Product Change Notification

1. ECN #: 242191

- IPBT - .165 DOUBLE ROW TERMINAL ASSEMBLY

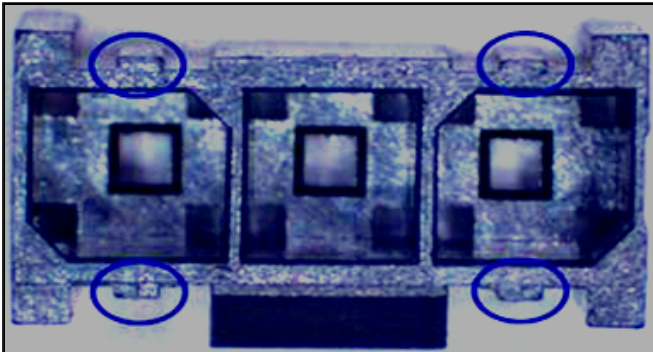
Center stand off ribs removed due to part size.

Visual inspection of assembly.

Old Part With Ribs.

New Part Without Ribs.

Due to small size of part, the ribs were removed. There will be no change to the function of the assembly.

- Form - Ribs removed
